CITY OF LAVON Agenda Brief

Discussion and action regarding the site plan and landscape plan of the Lavon Retail Project at 616 Cedar Street on Lot 4, Block F of the Replat of Lake Breeze Estates Block A, Lot 32C Addition on 1.22 acres out of the Samuel M. Rainer Survey, Abstract No. 740, northwest of the intersection of S.H. 78 and Cedar Street, City of Lavon, Collin County, Texas (CCAD Property ID 2918093).

Re: Lake Breeze, Lot 4
Revised Site Plan Review
LJA Job No. NTP-3880
MyGov Submittal: September 17, 2026

Re: Lake Breeze South Commercial – Lot 4 - 1 Lot, 1.227 Acres
Lavon Retail
Site Plan Review

LANDSCAPE PLAN

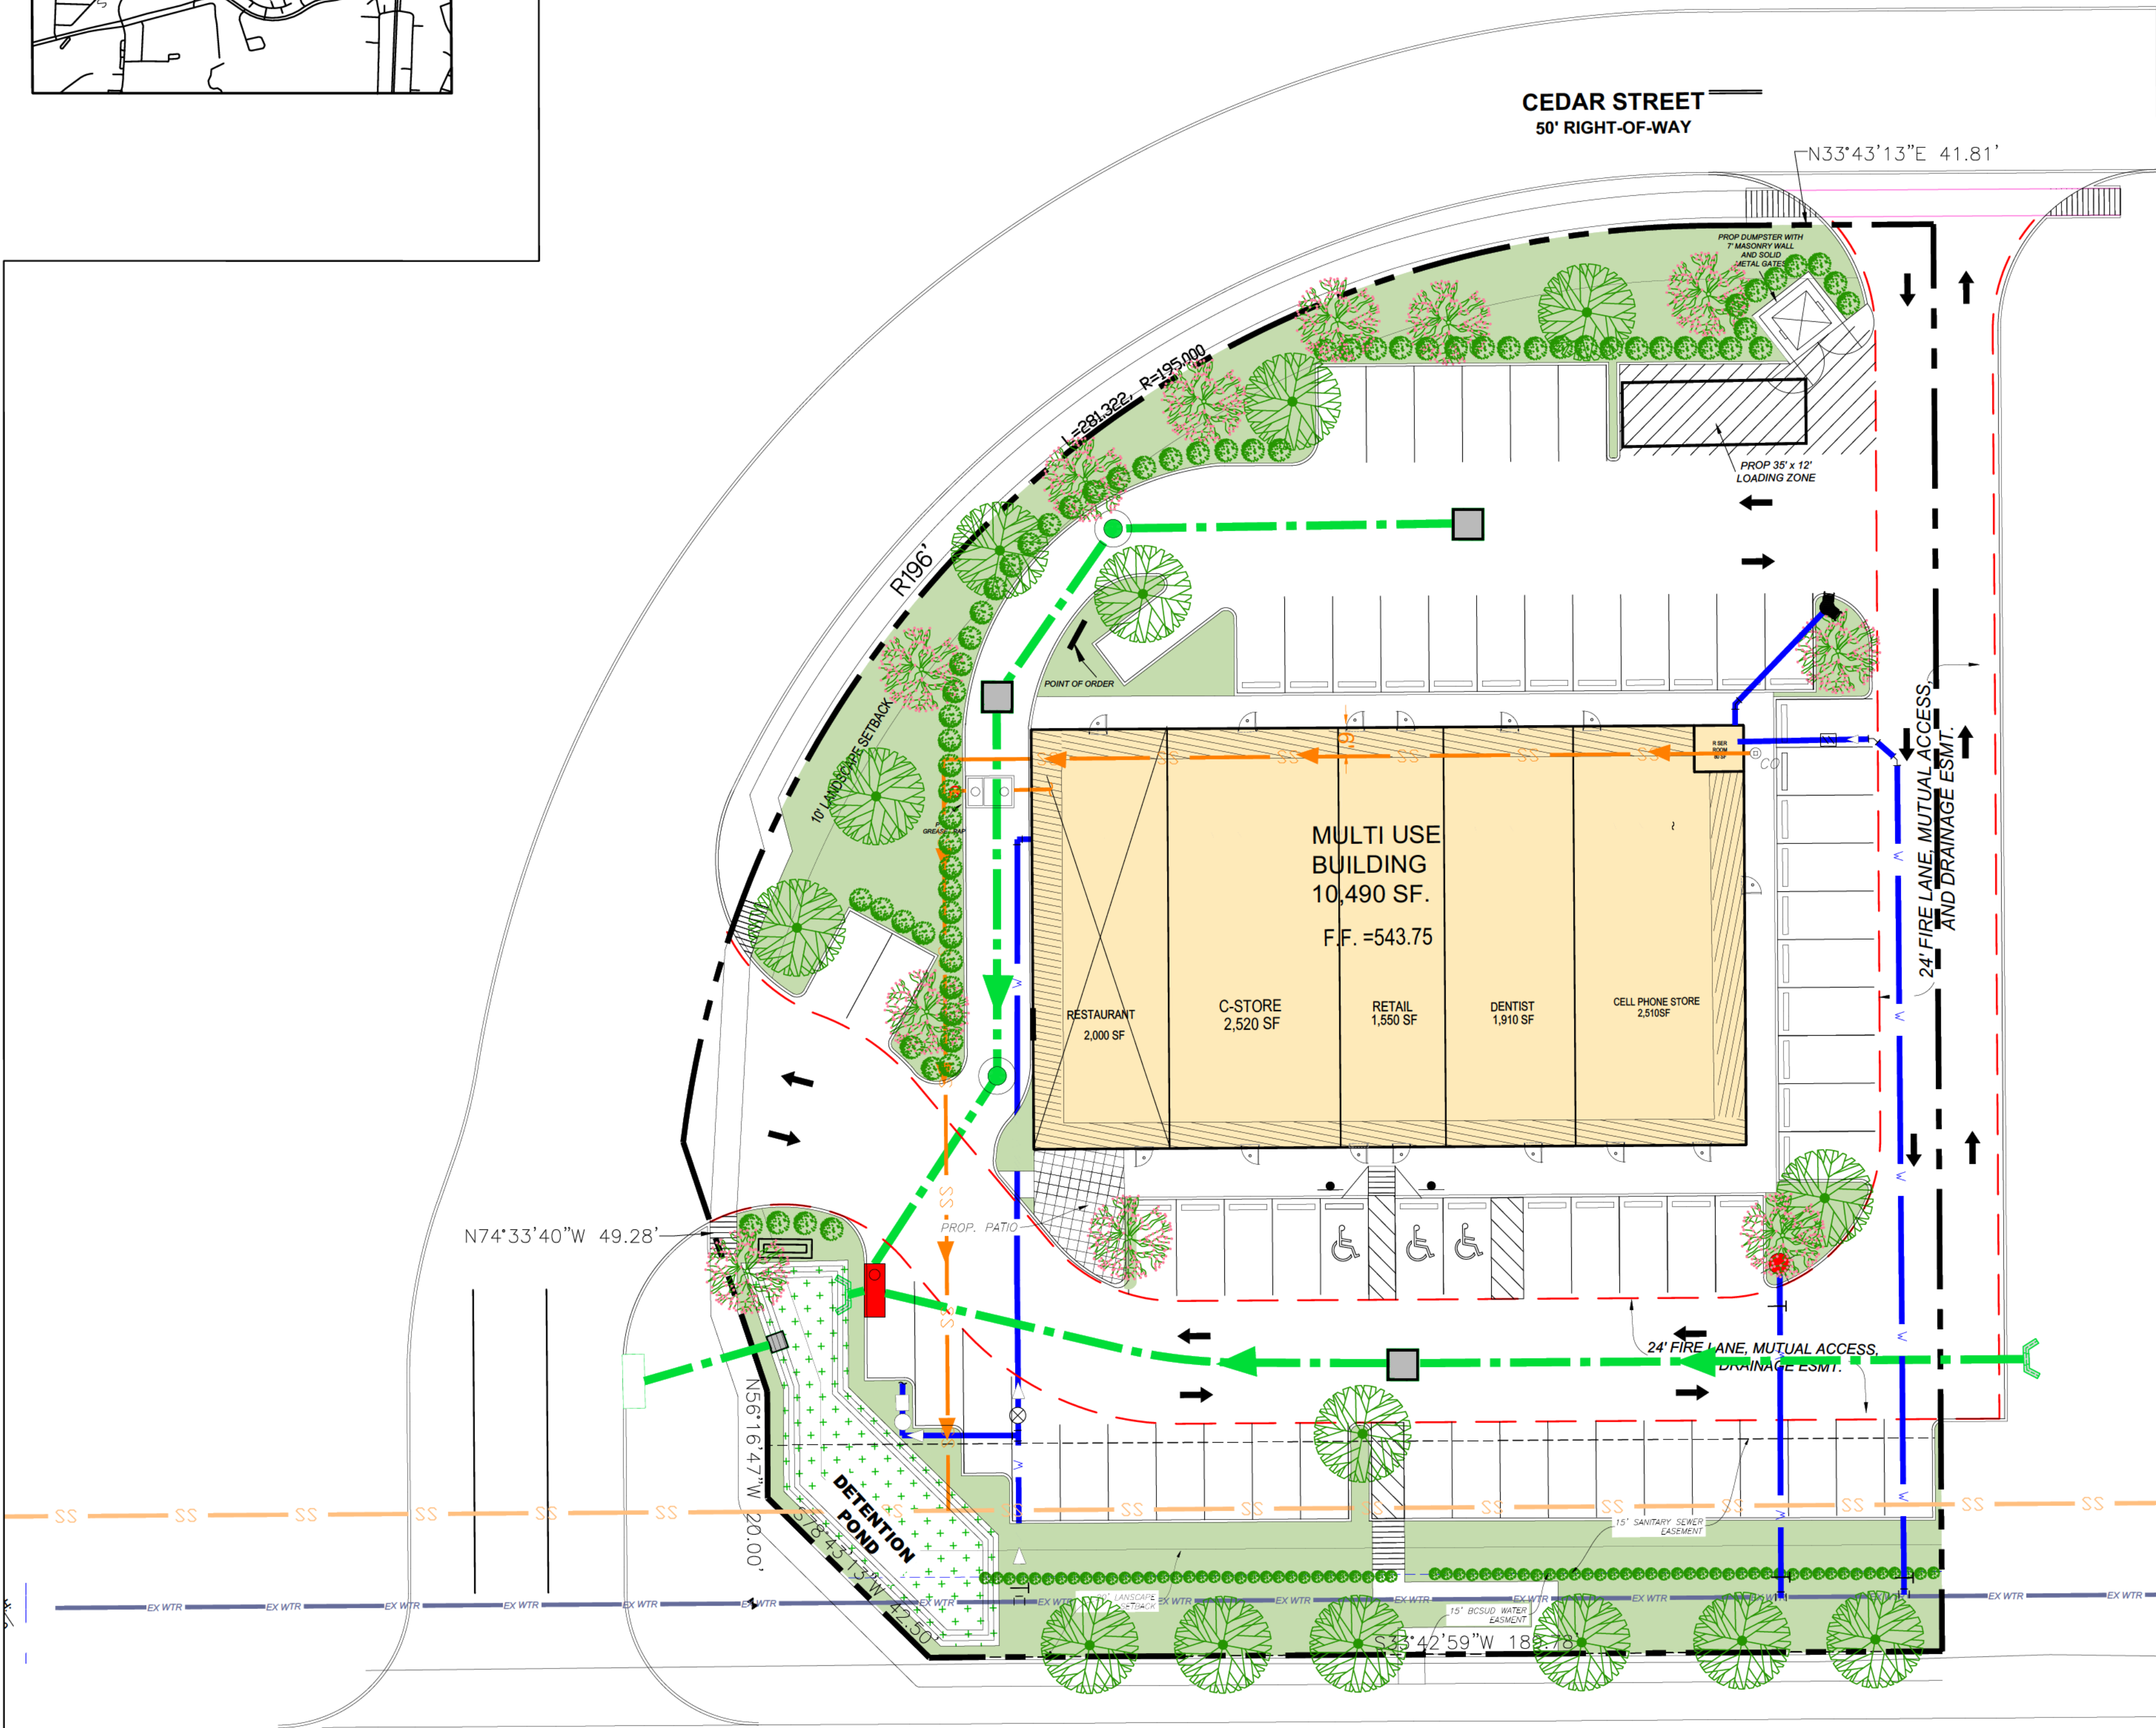
- REPEAT COMMENT:** Revise the Landscape Plan to provide canopy trees along SH78 as shown on the approved Landscape Plan. If there are any utilities lines not included on the Landscape Plan please include them in the next revision and ensure that all proposed trees are a minimum of eight feet from public utility lines.

The Landscape Plan has been revised to provide canopy trees along SH78 at a rate of 1 per 25 feet. However, these trees are approximately 4 feet from the existing water line. Additionally, the legend indicates that the canopy trees shown on the Landscape Plan are either Live Oak or Canadian Maple, and the shrubs are Nandina Sienna Sunrise. Canadian Maples canopy trees and Nandina Sienna Sunrise shrubs are not on the approved plant list per § 9.03.193(m) of the Lavon Code of Ordinances. Revise the Landscape Plan to ensure that all proposed trees are a minimum of eight feet from public utility lines and all plant materials are from the approved plant list.

Addressed and updated on the plan to list approved plants and adjusted plant to meet the 8 foot requirement

Recent submittal

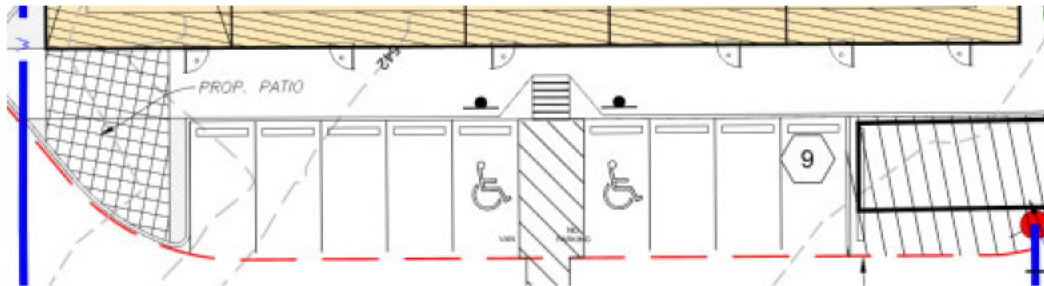
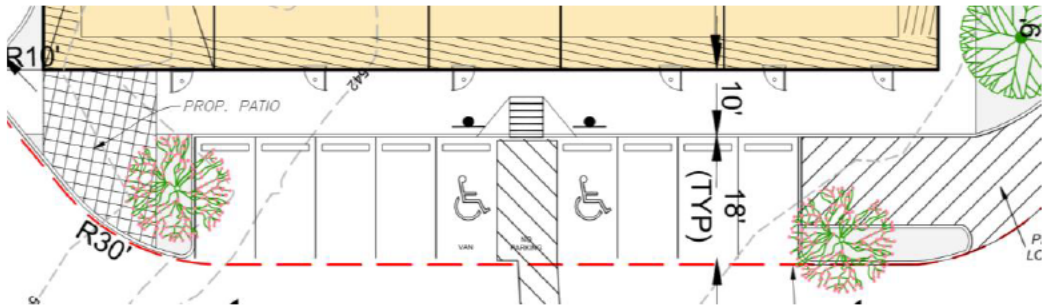
8. Revise the Site Data Table to include the maximum height of the building.
Addressed and updated on the plan
9. Revise the Landscape Plan to provide terminus trees in the following locations, as shown on the previously submitted Landscape Plan.

Addressed and Updated on the plan

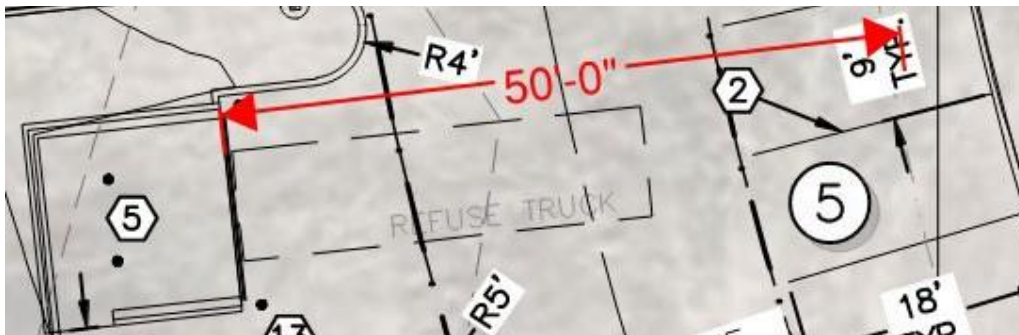
1. REPEAT COMMENT: A minimum 20-foot landscape buffer is also required along the northern property boundary, including a canopy tree every 30 linear feet, per the PD. Revise the Landscape Plan, Sheet LP-1, to include landscaping materials and trees as required on the north side of the property, adjacent to the existing residential properties. Coordinate with the city engineer as this area also includes utilities.

Response: The trees within the 20' landscape buffer have been spread out to avoid being clustered. The three western-most trees are spaced at 7' from the trunk to the proposed private sanitary service line to keep them within the buffer. However, this sanitary line is not public, and there are not concerns with the spacing.

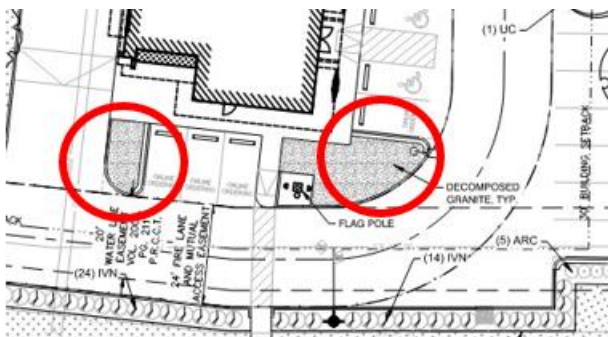
6. Staff recommends adding trees at the terminus of all parking rows.

Response: Trees have been added in these areas as recommended.

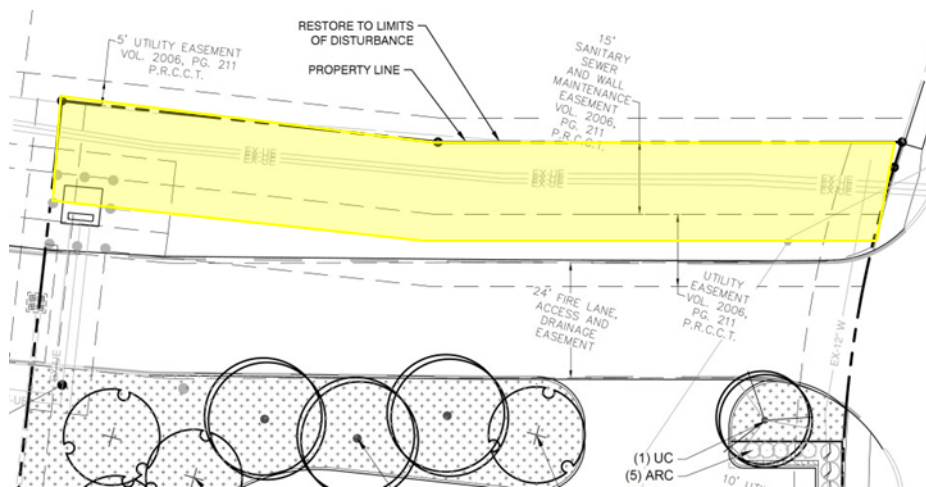
9. Provide a label on the site and landscape plan for the dumpster enclosure. A dumpster enclosure must be a minimum of six (6) foot tall masonry wall with a solid gate.

Response: Label has been added.
